Justification for Manual Deactivation

AEB IWG 06 – Industry Input

Example (current AEBS):

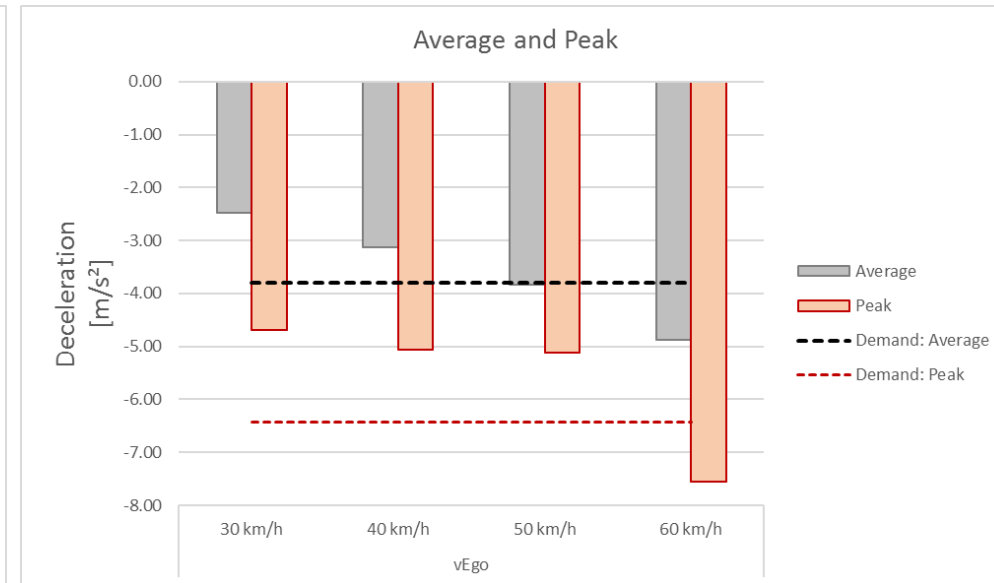
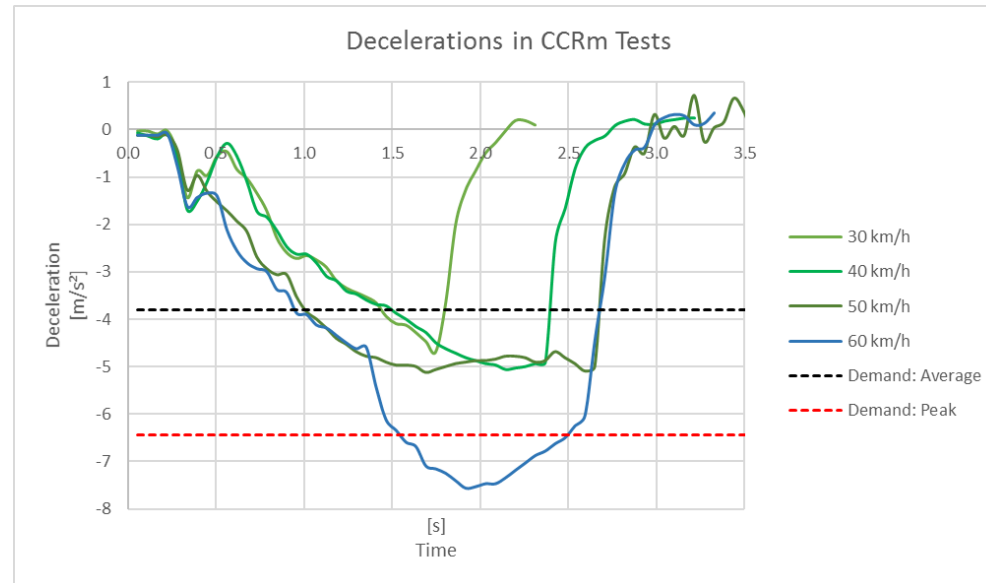
Braking from 30 km/h to 20 km/h on a moving vehicle

Peak approx. $-4,6 \text{ m/s}^2$

Average approx. $-2,3 \text{ m/s}^2$

Speeds up to 30km/h relative speed did not achieve the vehicle deceleration required by the draft regulation.

Using AEBS as a comfort function is unlikely. The peak deceleration of more than 4 m/s^2 and a remaining gap to another vehicle less than 1 m in an AEB event are uncomfortable for the driver and very uncommon considering normal driving.

CCRM-Scenarios

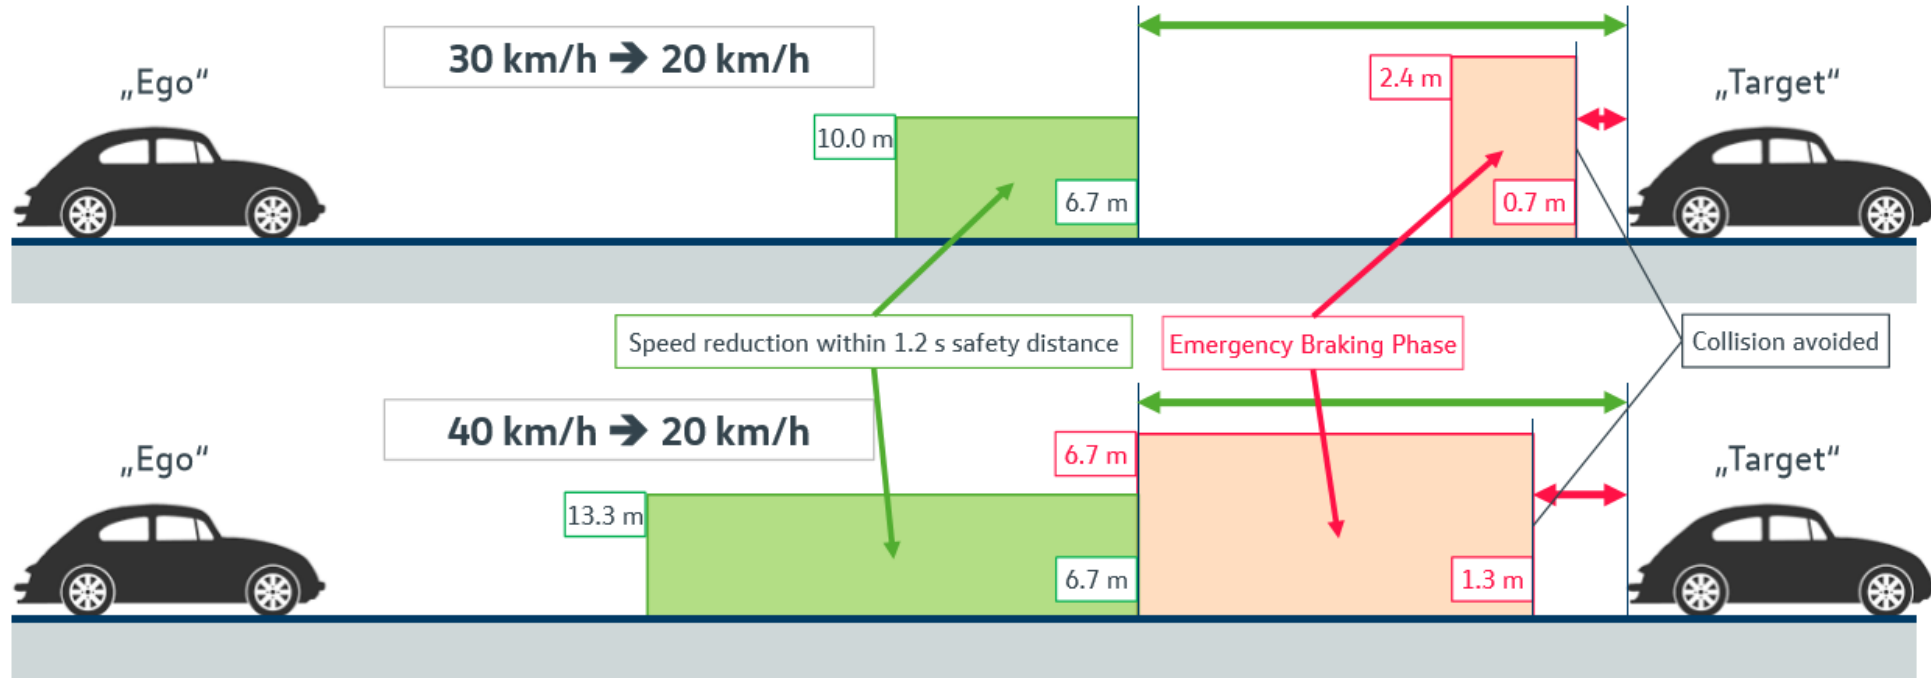
In both scenarios collisions are avoided with decelerations below the demanded average (-3.8 m/s^2) and peak (-6.43 m/s^2) deceleration values.

Nevertheless those AEB are not considered convenient – not only because of the level of the deceleration, but because of starting and ending distance of the braking phase itself.

In order to reach the demanded deceleration values the AEBS

- has to **brake later** (= loss of safety in case of wet street, braking target, ...) or
- will **stop the vehicle in greater distance** to the target (= no acceptance of the customer)

Deceleration of light truck

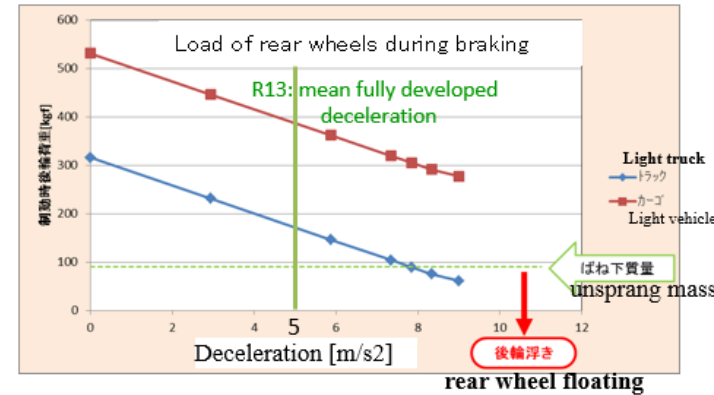
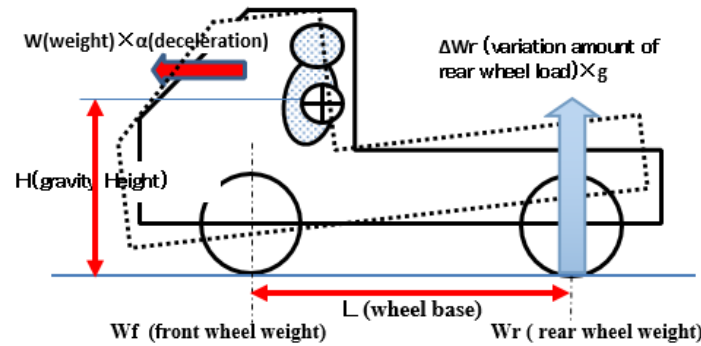
The deceleration of the light truck is limited up to around 7 m/s² because of the rear wheel load reduction.

As the wheel base L is small (H / L is large), the rear wheel load fluctuation amount ΔW_r increases. Further, when the rear wheel load W_r is small, the rear wheel load greatly decreases.

If the rear wheel load W_{rB} of braking falls less than the rear wheel unsprung mass w_r , the rear wheel floats. That is, if $W_{rB} - w_r =$ negative, the rear wheel floats.

Influence of Short Wheel Base

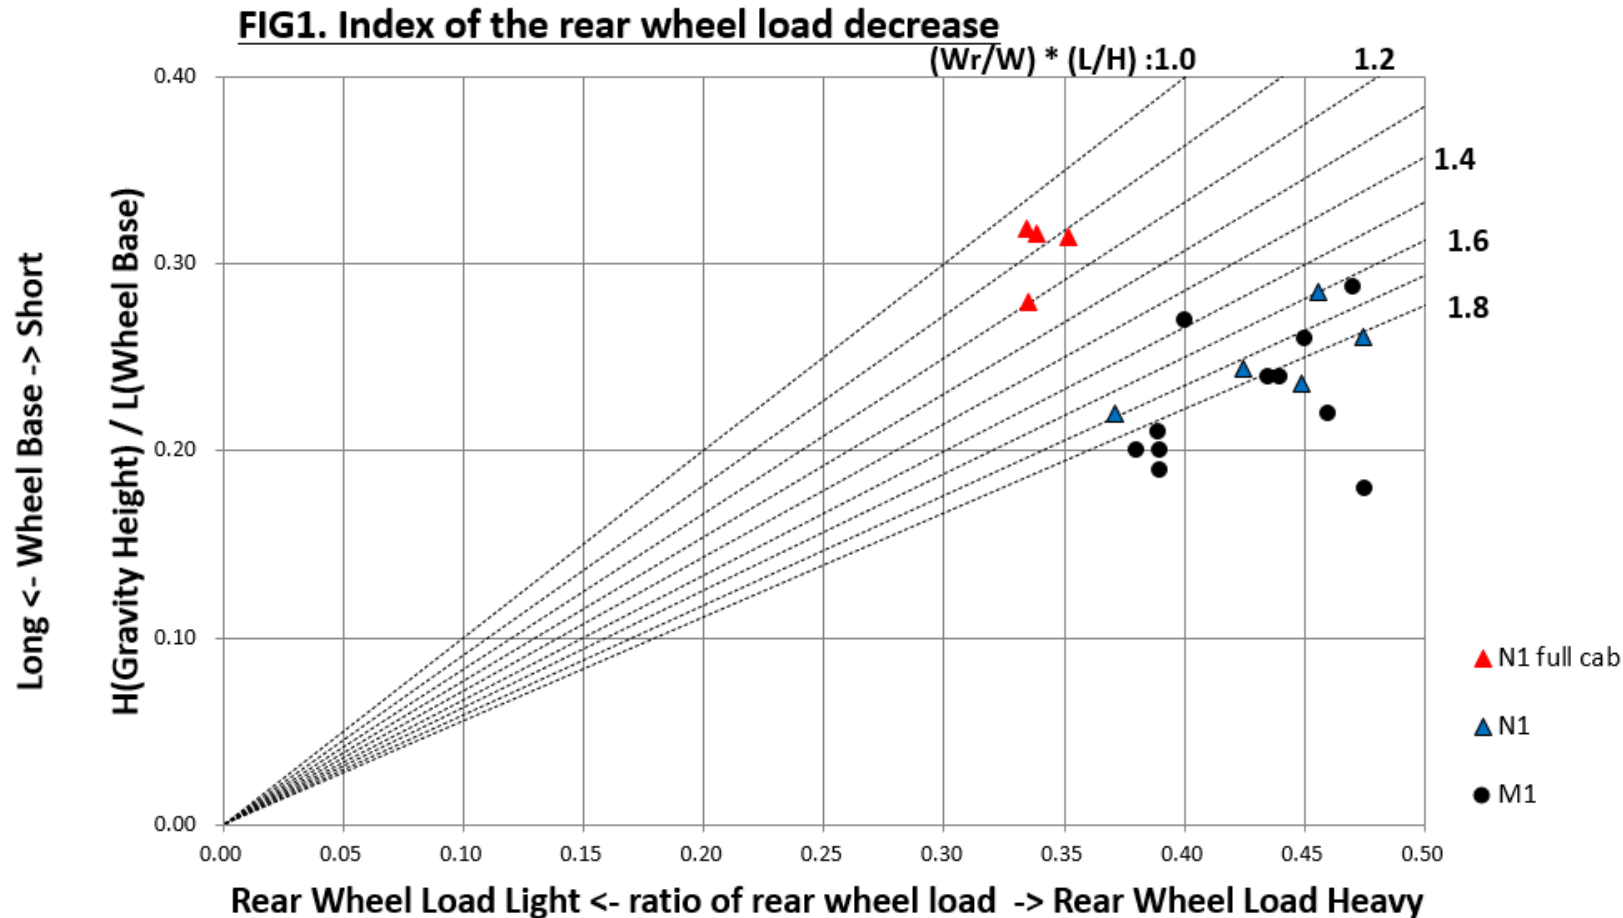
As for the vehicles of short wheel base , the braking force is controlled due to decrease the rear wheel load.
